DART AEROSPACE LTD		Work Order:	47658
		Part Number:	D3492-1
Description: Plug			
Inspection Dwg: D3492 Rev: C			Page 1 of 1

DRAWING NO. D3492
REV. C
SHEET 1 OF 2
TITLE PLUG
SCALE 2:1

DRAWING NO. D3492	TITLE PLUG	REV. C	DART AEROSPACE LTD ENGINEERING ORDER		D.E.O. NO. D3492-C-1	SHEET NO. SHEET 1 OF 1	SCALE NTS
DRAWN AJS		CHECKED	MFG. APPR.	APPROVED	DE APPR.		
DATE 08.11.05		DATE 08.11.05	DATE 08.11.05	DATE 08/11/05	DATE 08/11/05

DETAIL D

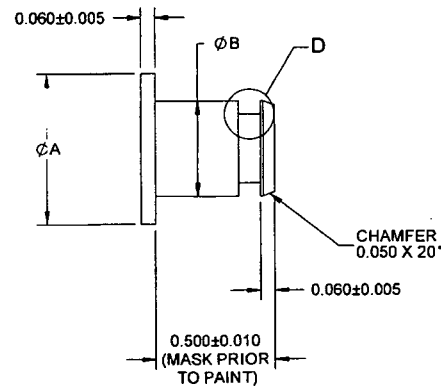
SHEET 2 MODIFY -13 PLUG AS SHOWN:

WAS:

P/N	A	B	C	MATERIAL SPEC
D3492-13	0.750	0.520	0.045	M6061T6R0.750

IS:

P/N	A	B	C	MATERIAL SPEC
D3492-13	0.750	0.510	0.045	M6061T6R0.750
